**Comanche Peak Nuclear Power Plant, Units 3 & 4
COL Application**

FSAR Revision 2

Update Tracking Report

Revision 1

Figure 2.5.1-229 Gas Production from the Newark East Field in the Barnett Shale

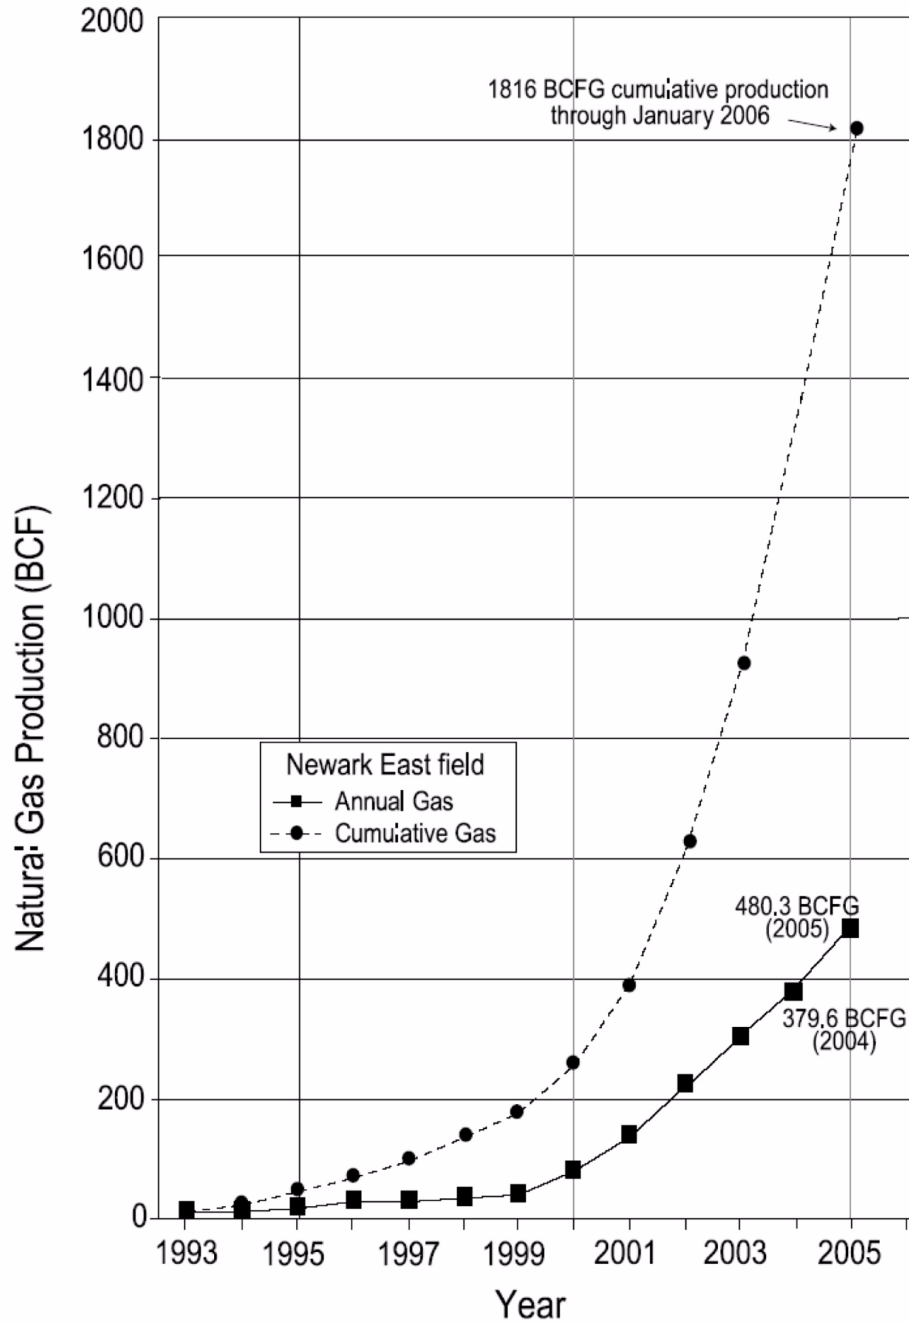
CTS-01417	Figure 2.4.7-201	-	Erratum	Corrected source, changed to Reference 2.4-245	1
CTS-01414	Figure 2.5.1-229	-	Editorial	Revised the Note on the figure to correct “incresea” to ‘increase’ and “Poliastro” to “Pollastro”	1

CTS-01414

Figure 2.5.1-230 1949 Historical Photograph

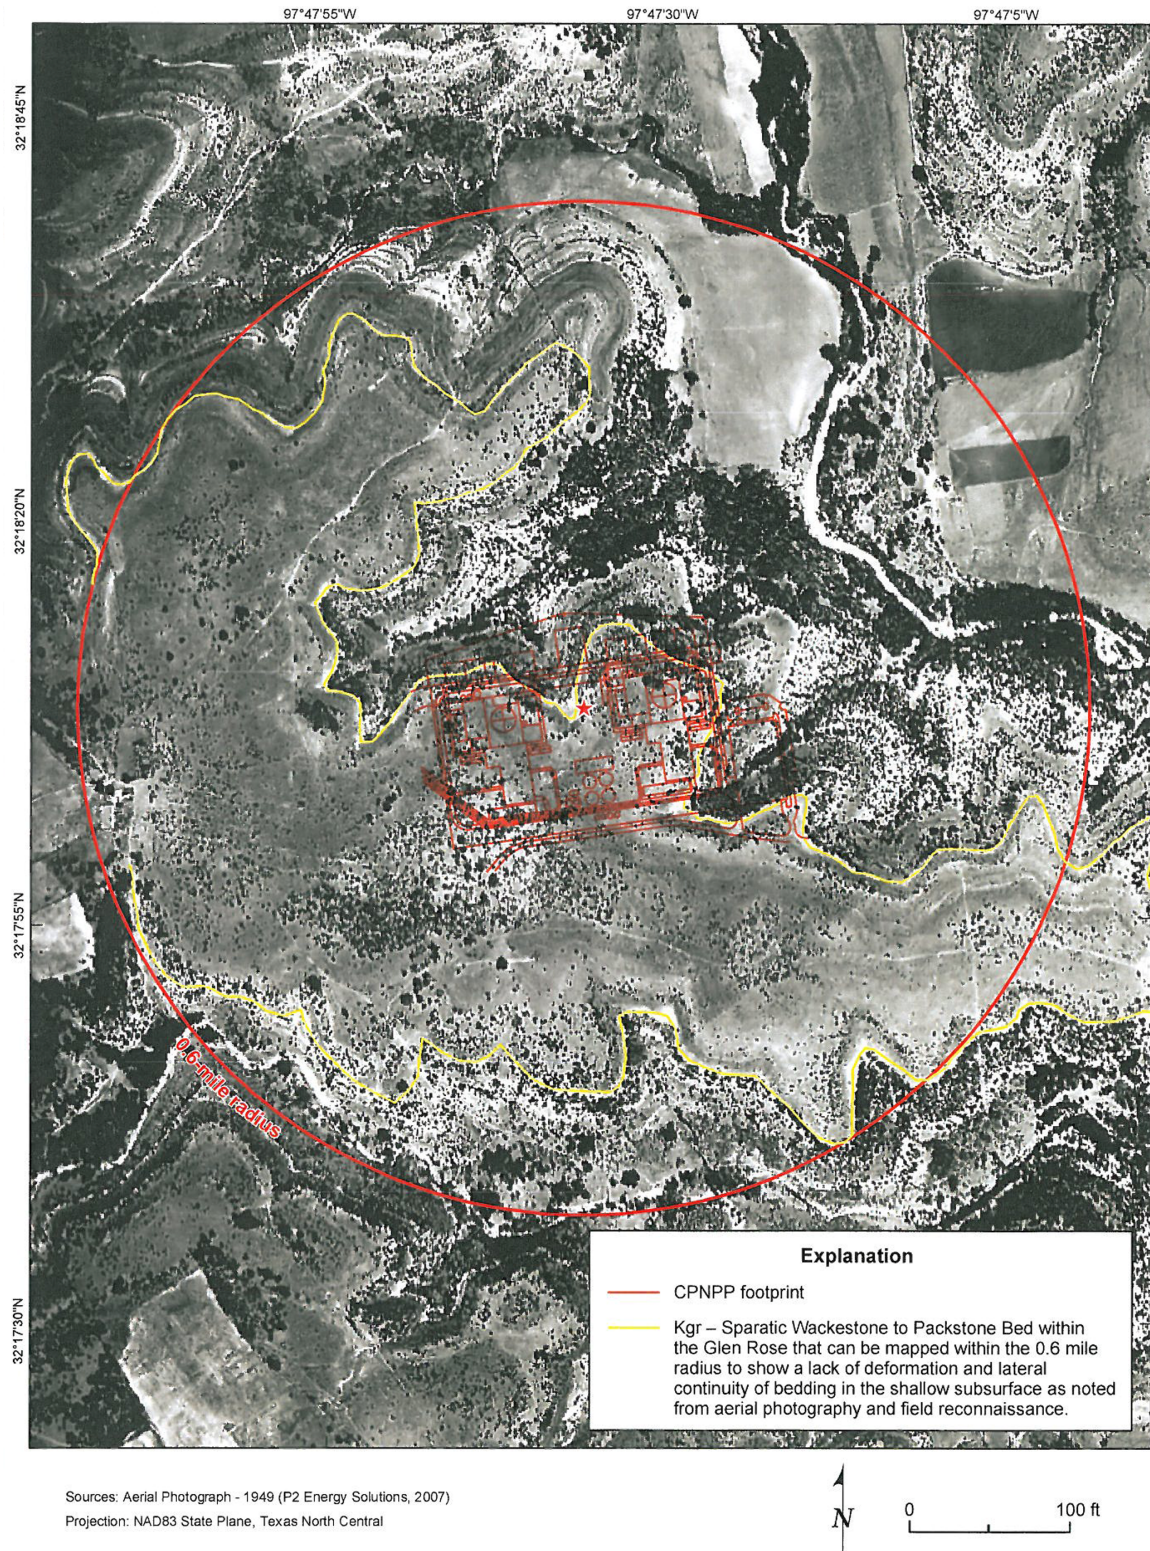
Change ID No.	Section	FSAR Rev. 2 Page	Reason for change	Change Summary	Rev. of FSAR T/R
CTS-01415	Figure 2.5.1-230	-	Editorial	Revised Explanation note on figure to correct typo; “subsurfaceas” was changed to “subsurfaces”.	1
CTS-01390	Figure 2.5.4-244	-	Editorial	Changed “Seismic earth pressure and compaction earth pressure not included” to “Seismic earth pressure not included” in Notes.	1

CTS-01415

Figure 3K-201 Location of Flood Barrier Walls UHSRS, ESWPT, and PSFSV

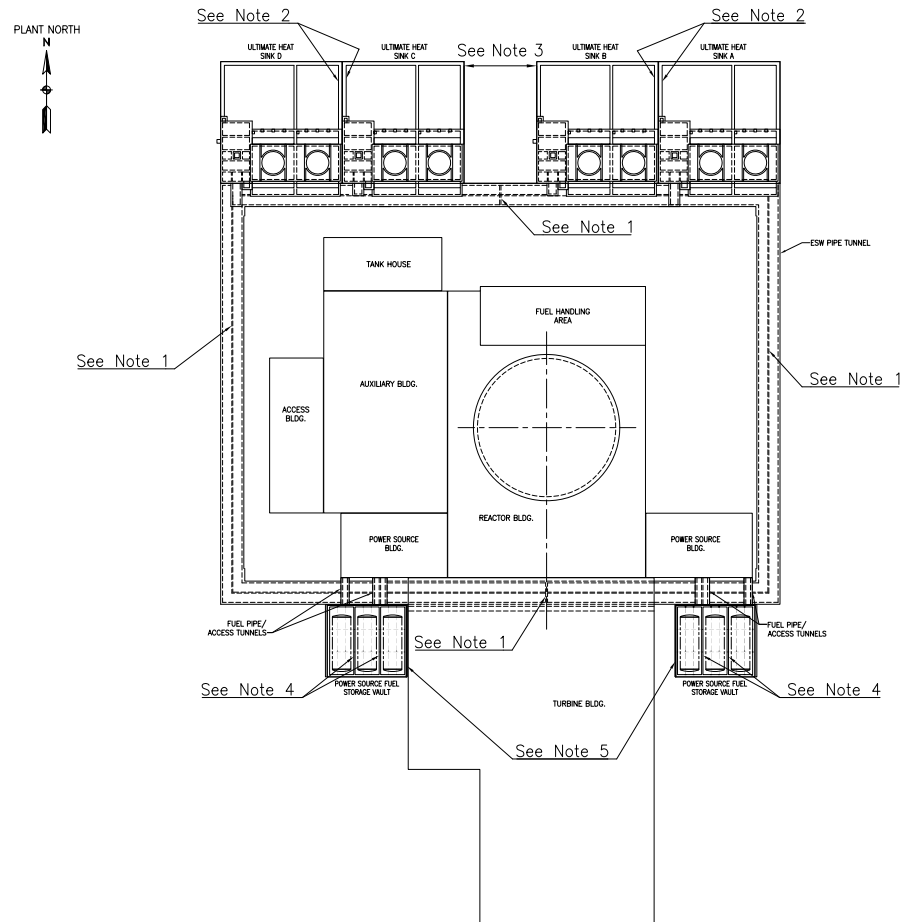
CTS-01394

Figure 10.4.8-1R Steam Generator Blowdown System Piping and Instrumentation Diagram (Sheet 1 of 2)

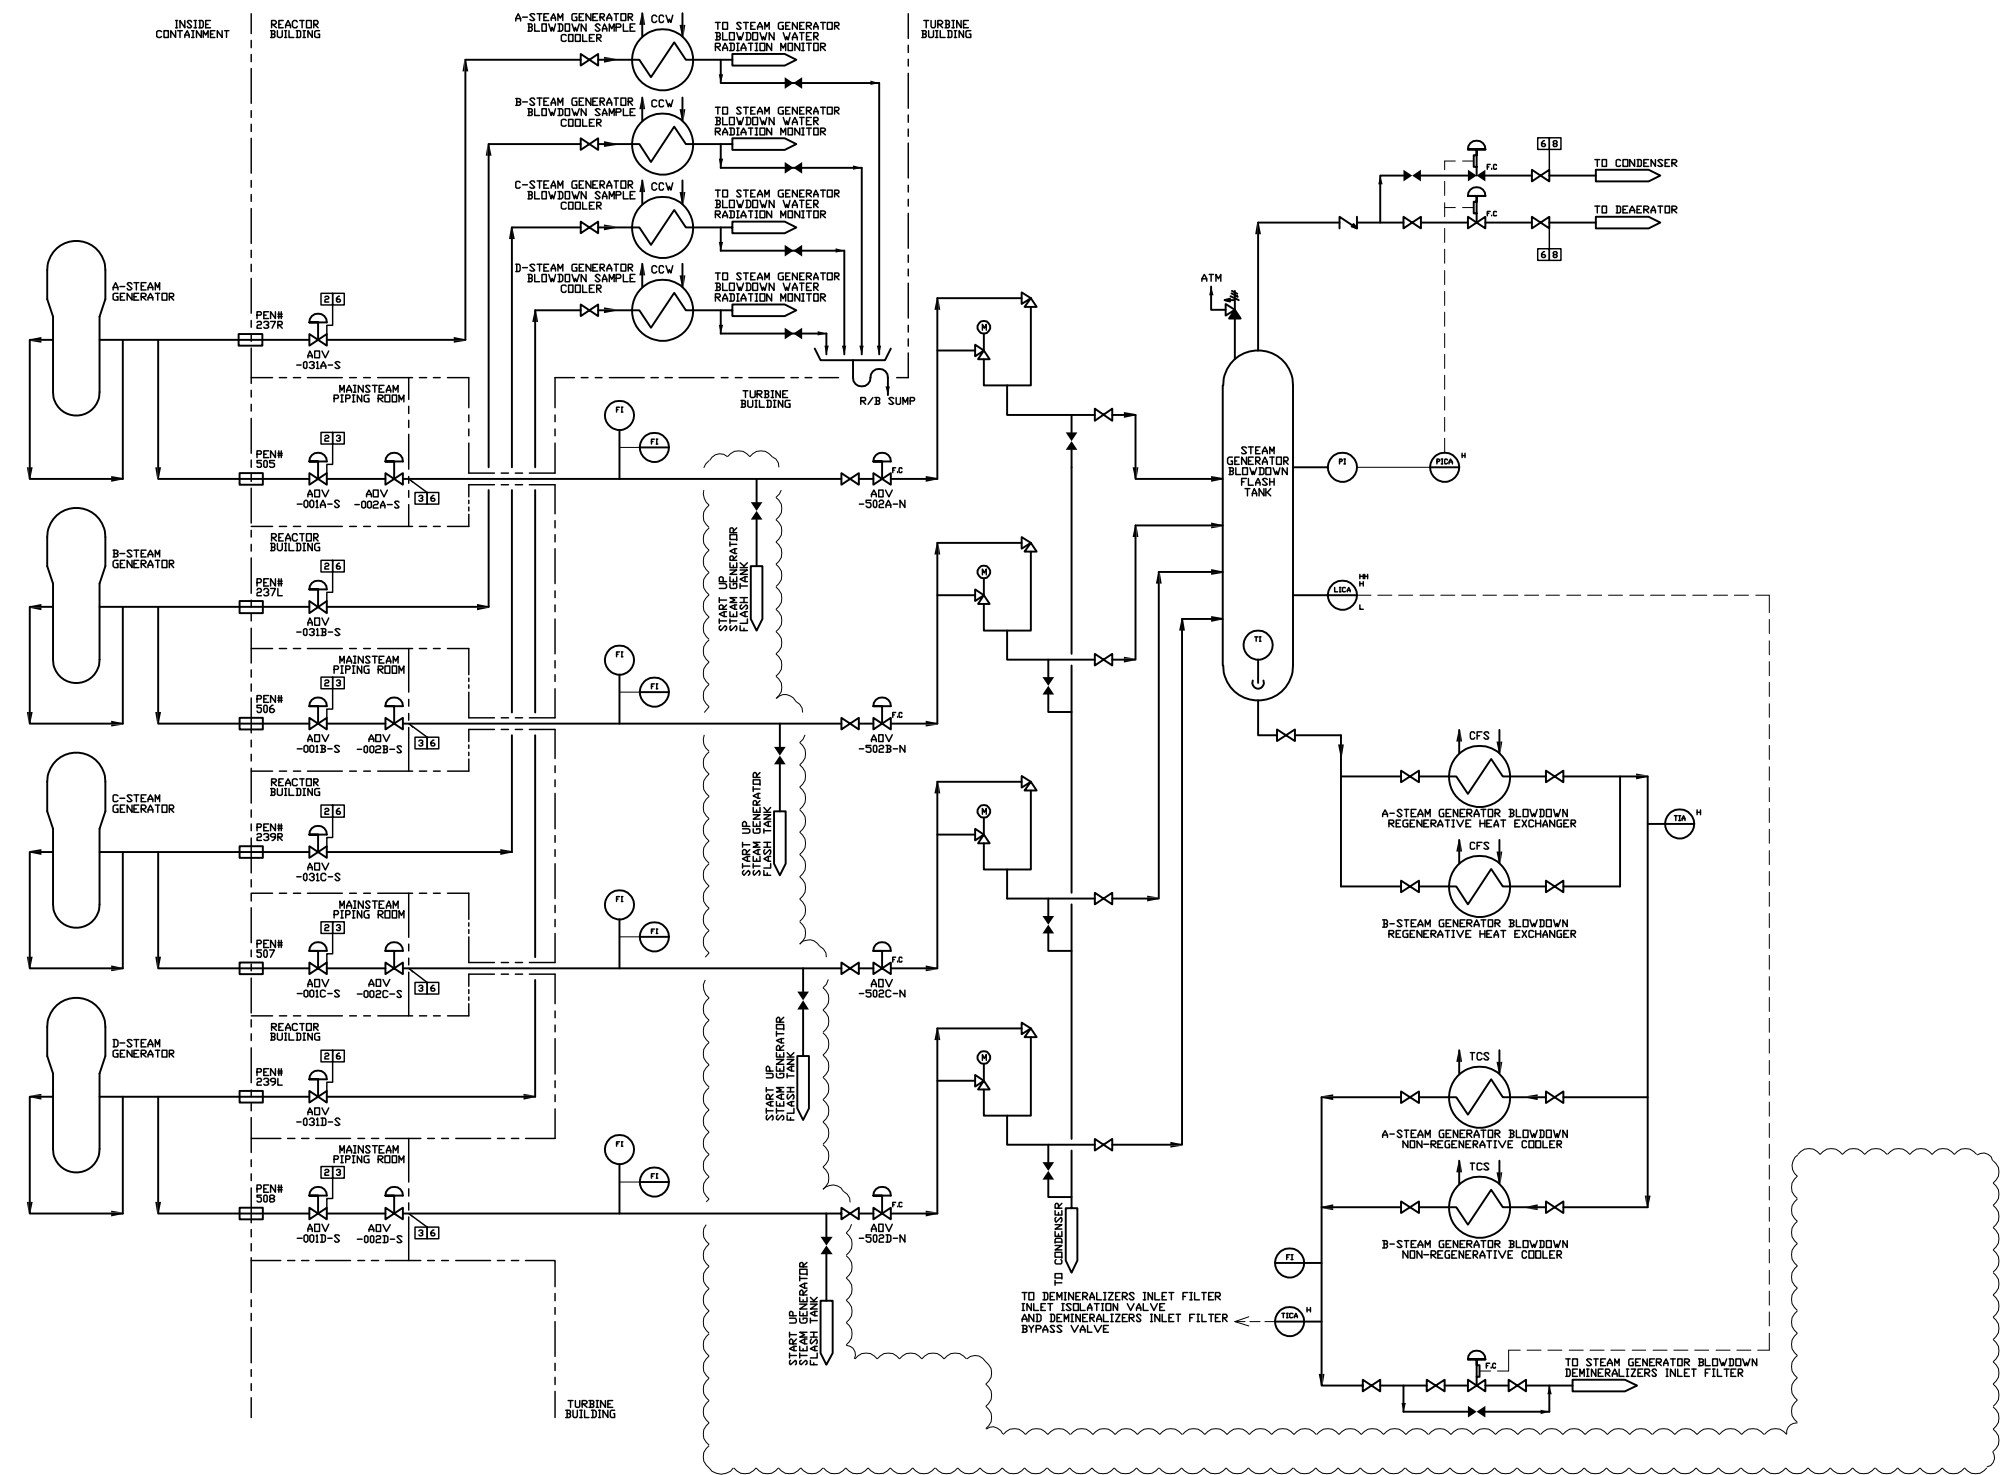
MAP-10-403

Figure 10.4.8-201 Steam Generator Blowdown System Piping and Instrumentation Diagram (Site-specific portion)

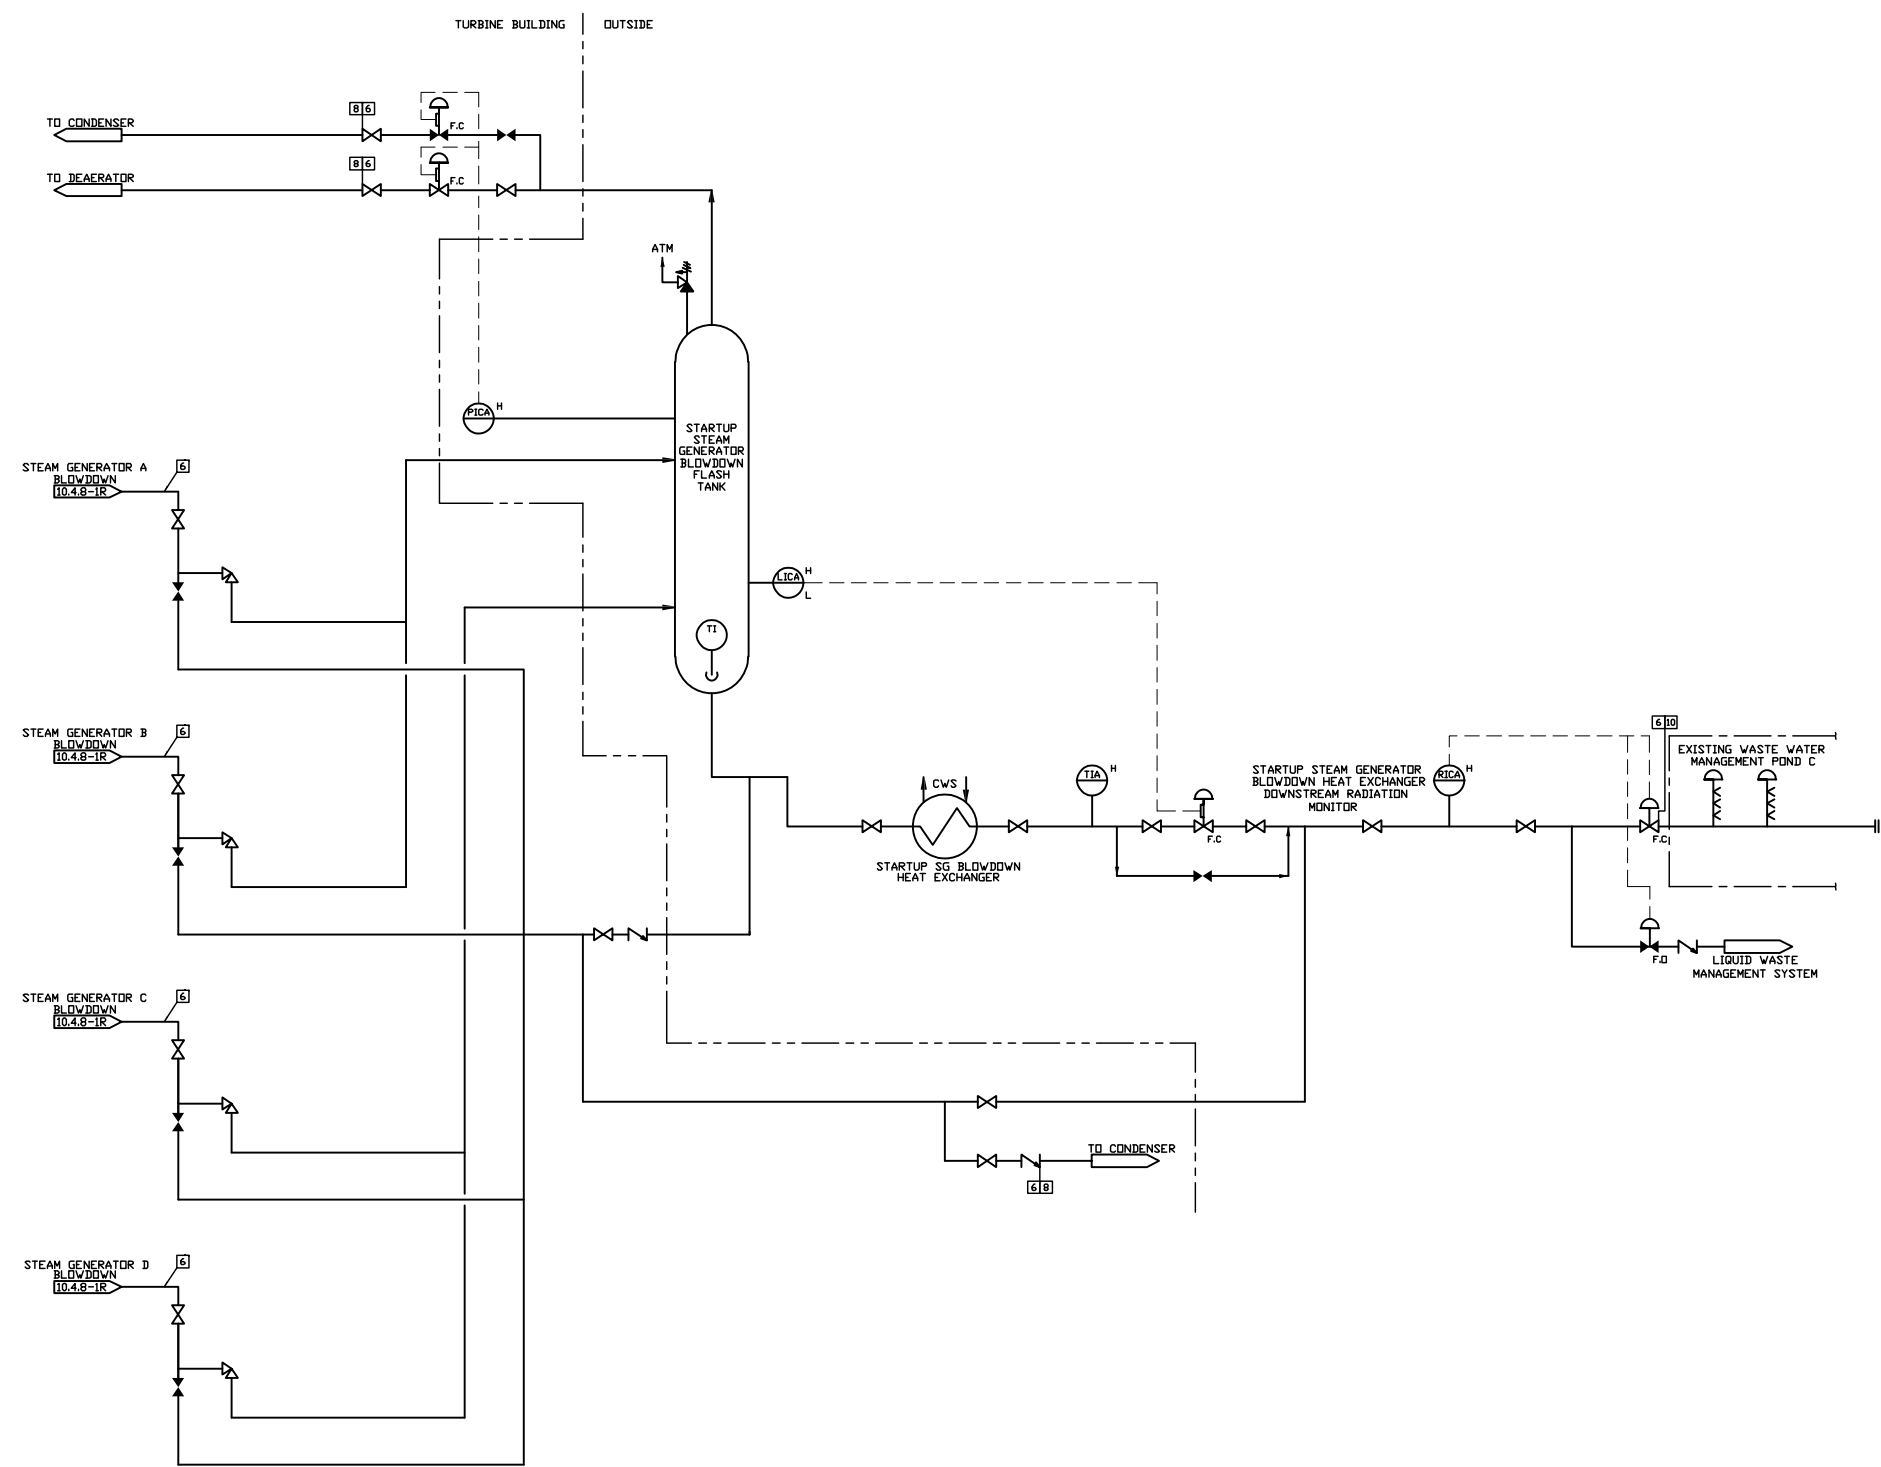
CTS-01436

Figure 13.1-202 Nuclear Generation Organization*

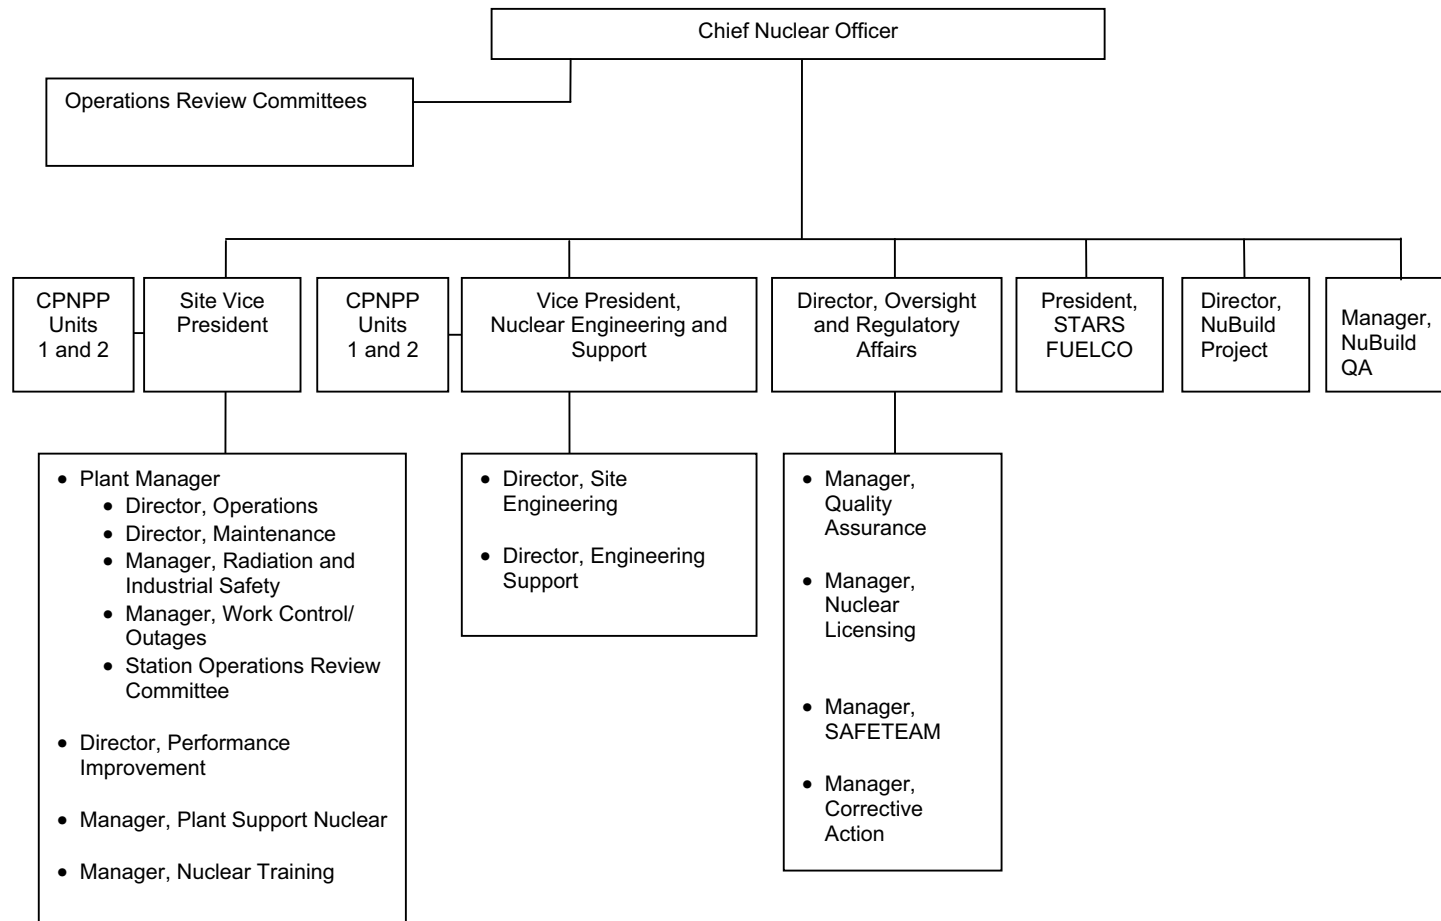
CTC-01393
